TO: Freightliner Principals, General Managers, Sales Managers, Service Managers, Parts Managers	FROM: Anthony Washington, Department Manager, Regulations and Certifications
Re: Recall Campaign Launch Notification Model - Sprinter Model Years 2019-2020 Modify Interior Blower Motor Fuse Layout	DATE: June, 2023

Campaign No. :	Campaign Desc. :	Modify Interior Blower Motor Fuse Layout
2023040008	VS30SIGEBL	
This is to notify you of a Recall Campaign Launch to modify the interior blower motor fuse layout on approximately 3,539 MY19-20 Freightliner Sprinter vans. The recall campaign will be visible on the www.safercar.gov website and may generate questions from customers. All affected VINs will be flagged “OPEN” in VMI and cannot be sold until remedied.		
Background		
Issue	Mercedes-Benz AG (“MBAG”), the manufacturer of Freightliner vehicles, has determined that on certain Sprinter (907 platform) vehicles, the fuse layout of the interior blower motor might not meet the requirements for prolonged operation at the highest blower setting. Ambient and assembly space temperatures as well as prolonged usage, could cause the wiring harness to overheat. Consequently, a risk of fire during operat

D83.10-A024-79

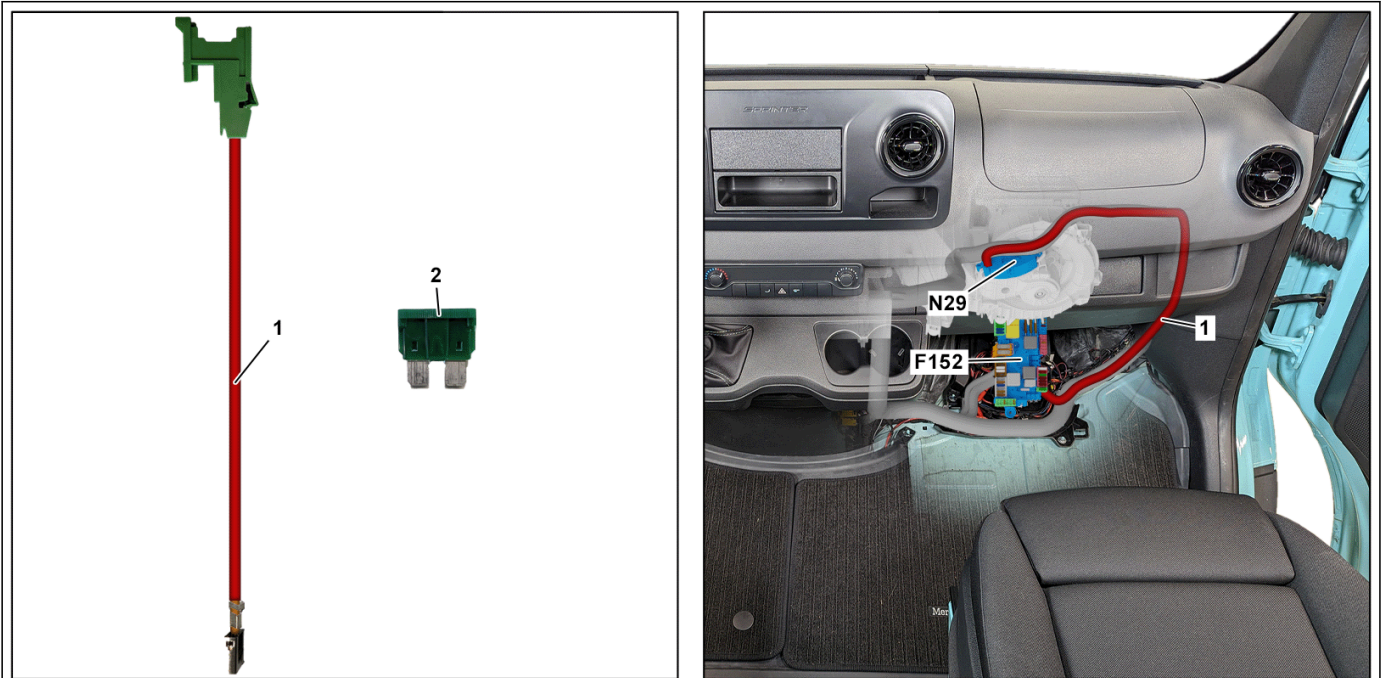
1	Electrical line	F152	Front-passenger-side fuse and relay module	N29	Blower regulator of inner blower
2	Fuse link

4.2	Remove bottom trim for instrument panel on front passenger side.	<p>Model 907</p> <p>except code FJ4 (Stowage compartment under cockpit)</p>	AR68.10-D-1502TSF
 AR			
	Retrofit electric lines (1)		
5	Retrofit electric line (1) for power supply of blower regulator of inner blower (N29).	<p> Wiring harness repair kit, basic</p>	<p>SM83.10-D-0013-02SG</p> <p>000 589 13 99 00</p>
